**CITY OF BOULDER  
LANDMARKS BOARD MEETING**

**DATE:** Wednesday, March 2, 2016

**SUBJECT:** Public hearing and consideration of a Landmark Alteration Certificate application to demolish an existing house built in 1957 and, in its place, construct a new 2,266 sq. ft. house at 2110 4<sup>th</sup> Street in the Mapleton Hill Historic District, per section 9-11-18 of the Boulder Revised Code (HIS2015-00254).

**SUBJECT:** Public hearing and consideration of an application for a Landmark Alteration Certificate to construct a 397 sq. ft. one-car garage at the Landmarked Perry White property located at 2303 Bluff St. , per section 9-11-18 of the Boulder Revised Code 1981 (HIS2014-00172).

Figure 15. Proposed Site Plan

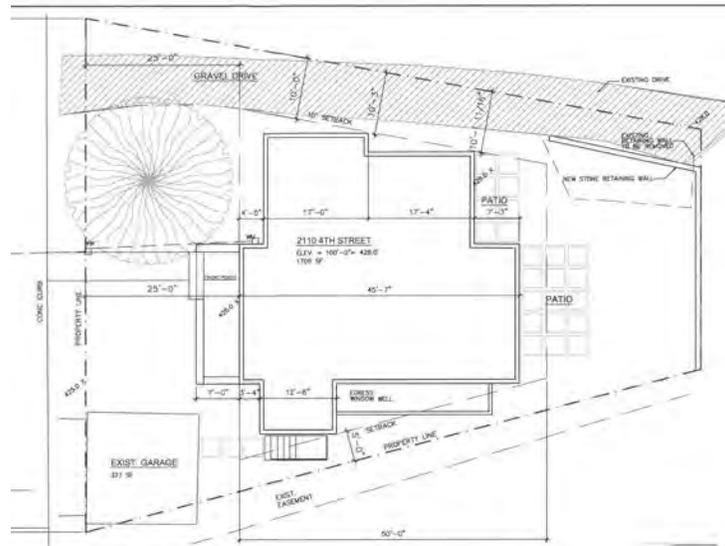
In plan, the proposed new house is shown to be located at approximately the same location as the existing house. The existing house is located approximately 26' from the west property line and the proposed house is shown to be located at the 25' front yard setback. The existing house measures approximately 35' wide and 26' long, with a 21'

The site plan indicates construction of rear retaining walls. No information was provided as to whether any changes to the contributing garage are contemplated as part of this project.

Figure 16. Proposed west elevation (façade)

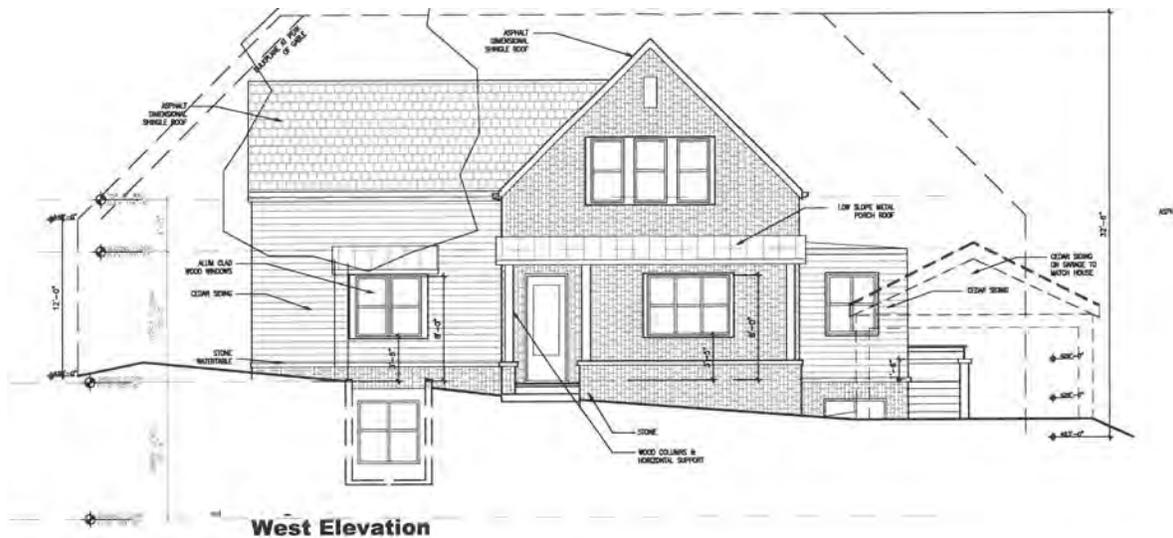
The first floor of the façade (west elevation), is shown to be fenestrated with ¾ light door on the porch and a set of one-over-one double hung sash and pairs of similar windows on the west face of the north and south portions of the house. A set of three one-over-one double hung sash is shown on the west upper-gable. A light-well is indicated at the north end of the west elevation, however, this feature does not appear on site or floor plans. Likewise, a basement window on the south ell on the west face is shown to rise several feet above grade, but a window well in this location is not shown in plan.

1. **Window-wall proportion:** Revise design so that the north, and west elevations have a traditional window to wall proportion (avoid large blank walls); consider revisions to reduce amount of blank wall on the façade (west). K. Remley referenced, Section U.8 of the *Mapleton Hill District Design Guidelines*.

2. Prior to submitting a building permit application and final issuance of the Landmark Alteration Certificate, the applicant shall submit the following, which shall be subject to the final review and approval of the Landmarks design review committee: final architectural plans that include revisions to ensure that the final design of the building is:

Figure 7. April 4<sup>th</sup>, 2015 (left) and Proposed Site Plans (right). Not to scale

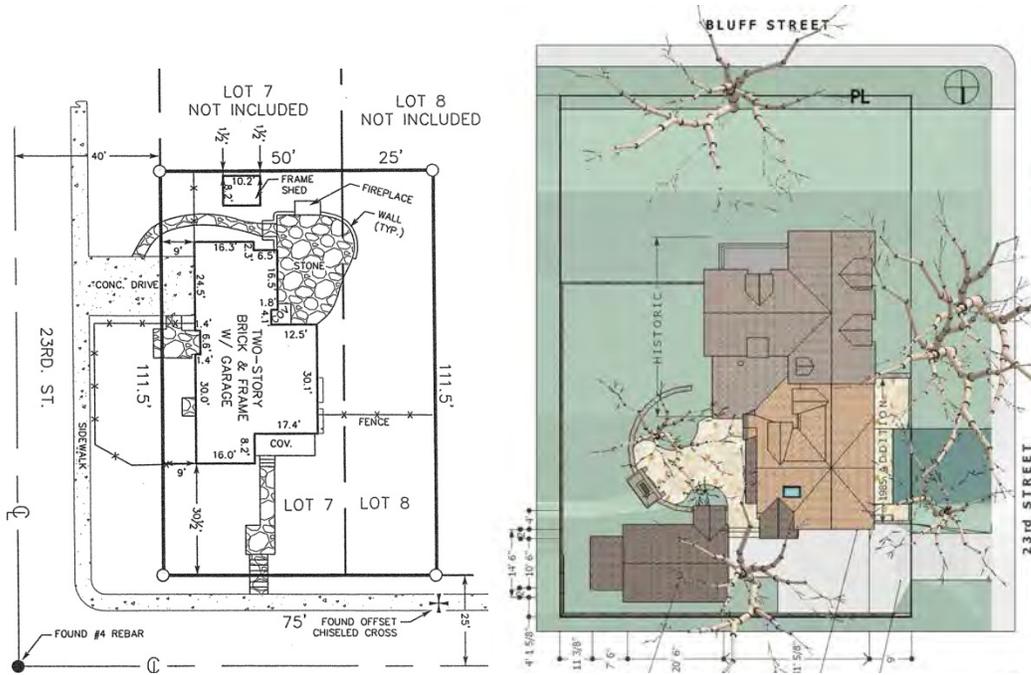
In plan, the southeast corner of the proposed garage is shown to be located approximately 8' from the northwest corner of the house. A large concrete driveway/apron is shown to link the garage to the new curb cut.

- b. Change the man door windows to single light; and
  - c. Show a reduced amount of driveway/paving area and the use of crusher fines or similar in front of the garage.

Figure 10. Proposed North Elevation (façade)

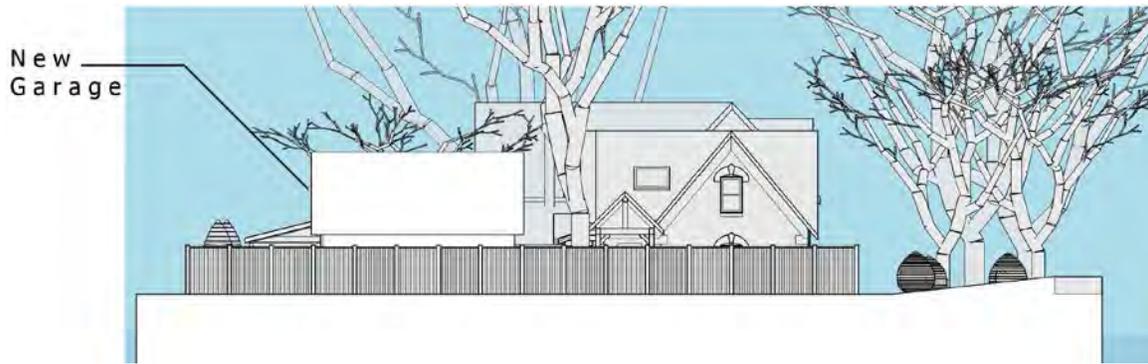
Elevations show the 397 sq. ft. one-car garage to be simply designed with a gable roof with pitch similar in proportion to the main house. The west face of the garage is shown to be located approximately 50' east of the west property line and to be accessed by way of a new curb-cut at the northwest. A simulated two-leaf door is shown to be set slightly asymmetrically on this face below a centrally located four light window set in the gable end. There is no adjacent alley and the

2. Prior to submitting a building permit application and final issuance of the Landmark Alteration Certificate, the applicant shall revise plans to:
  - a. Eliminate the half-timbered motif at the portico;
